Re: **Wood Farm Commercial Subdivision (Minor Amendment)**

MDP # 729-A

WOOD FARM COMMERCIAL SUBDIVISION
 PRELIMINARY OVERALL DEVELOPMENT PLAN - POADP #729A

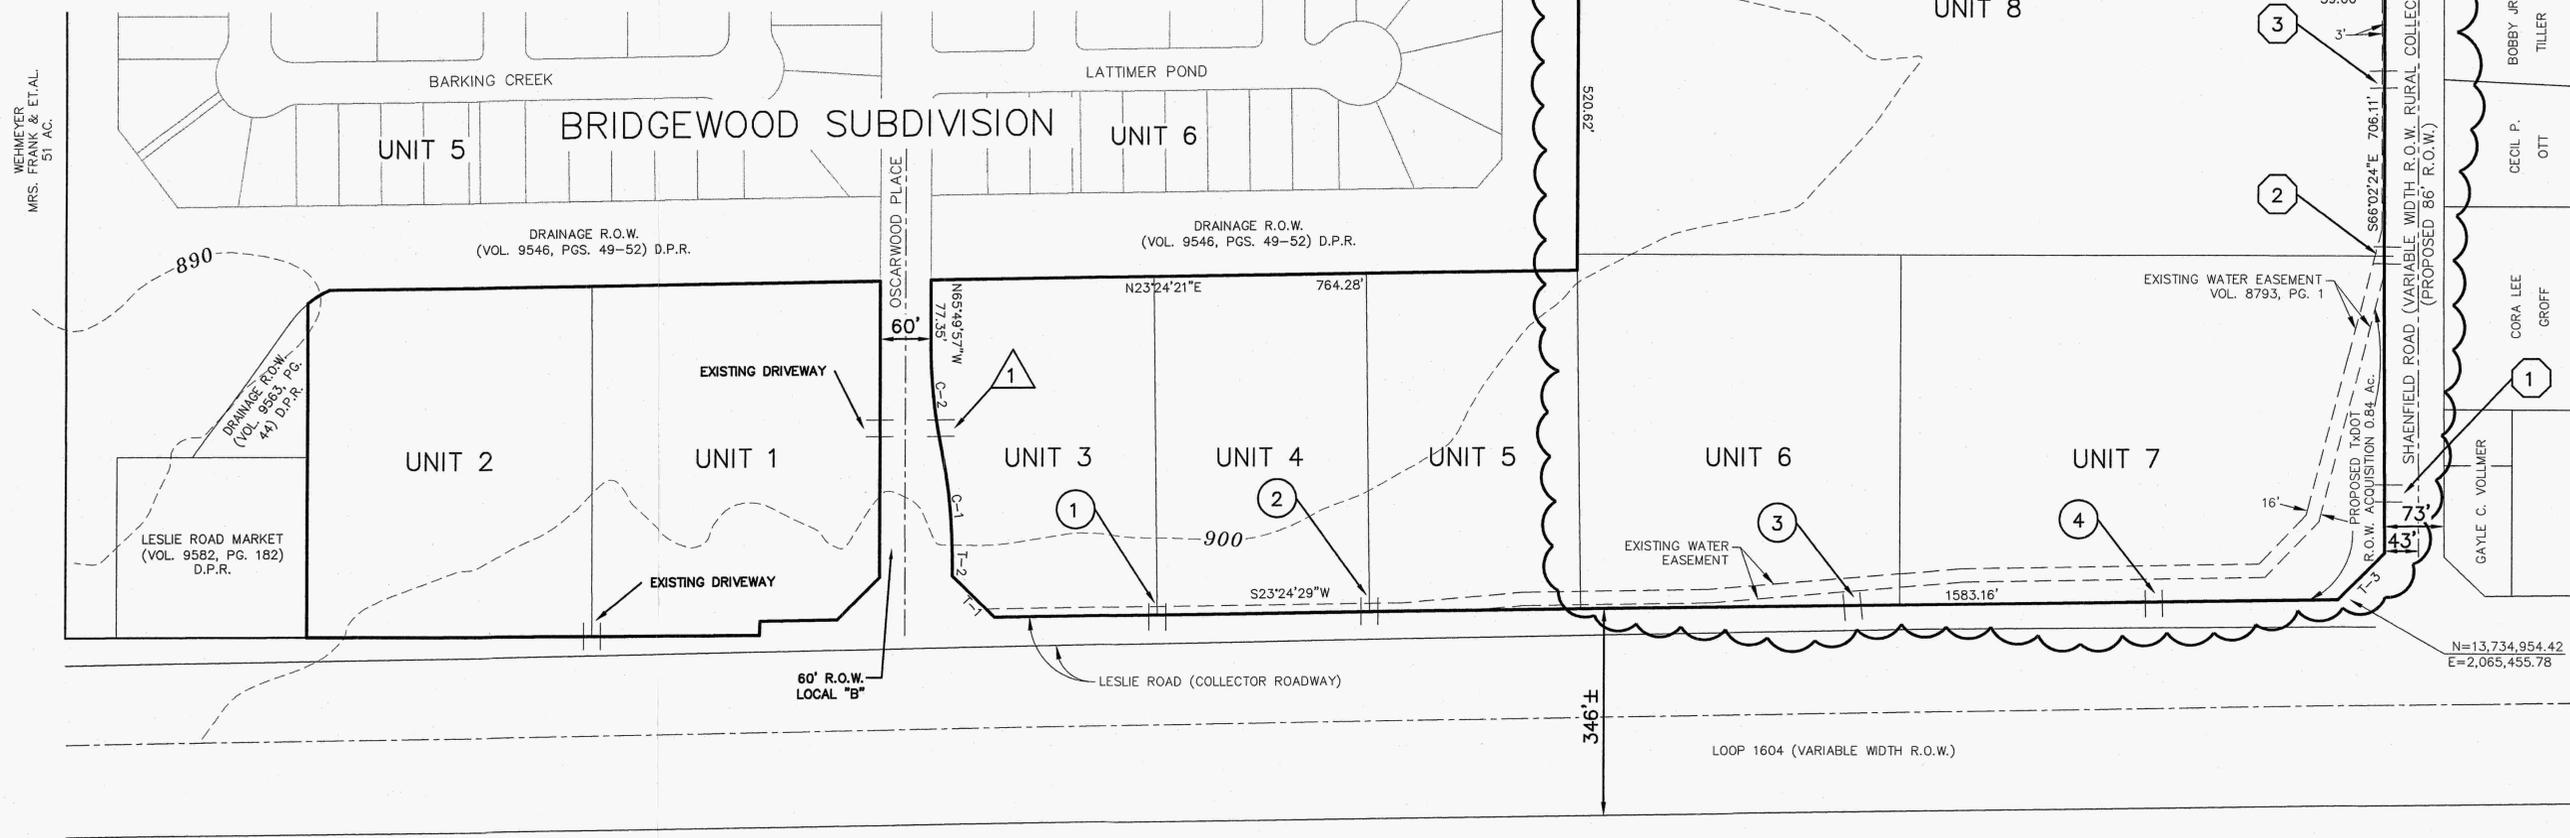
MINOR AMENDMENT A:

1. CHANGED PROJECT PHASING BETWEEN UNITS 6, 7, AND 8.

LOT 6 FROM 17.61 Ac. TO 3.40 Ac.
 LOT 7 FROM 1.15 Ac. TO 4.29 Ac.
 LOT 8 FROM 1.13 Ac. TO 12.10 Ac.
